**From:** [Williams, Shawn](#)  
**To:** [Vaughan, Jordan L](#); [Grzeck, Lee](#)  
**Cc:** [Scarborough, Thomas](#)  
**Subject:** Summary of May 4, 2022, Clarification Call with Duke Energy Carolinas, LLC, regarding the license amendment request to revise TS 3.7.7, "Low Pressure Service Water (LPSW) System" (EPID L-2021-LLA-0157)  
**Date:** Wednesday, May 04, 2022 11:00:55 AM  
**Attachments:** [image001.png](#)

By application dated September 2, 2021 (Agencywide Documents Access and Management System (ADAMS) Accession No. ML21245A210), Duke Energy Carolinas, LLC, (Duke, the licensee) requested changes to the technical specifications (TSs) for the Oconee Nuclear Station, Units 1, 2, and 3 (Oconee). The proposed change would revise TS 3.7.7, "Low Pressure Service Water (LPSW) System," to extend the completion time for one required inoperable LPSW Pump on a temporary basis for Oconee. In response to a Request for Additional Information (RAI) (ADAMS Accession No. ML22063A450), Duke submitted a supplement dated April 14, 2022 (ADAMS Accession No. ML22104A010).

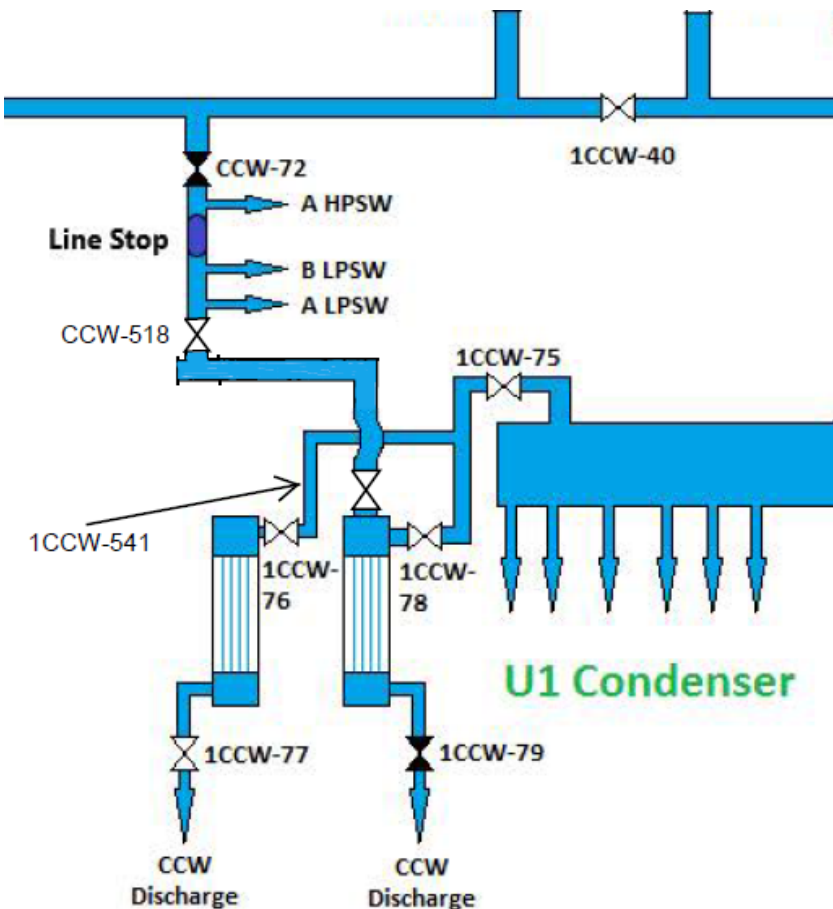
The NRC staff requested clarification regarding the location of the future installation of the CCW-518 and 1CCW-541 valves that were described in the EMIB RAI responses.

The licensee provided the below illustration.
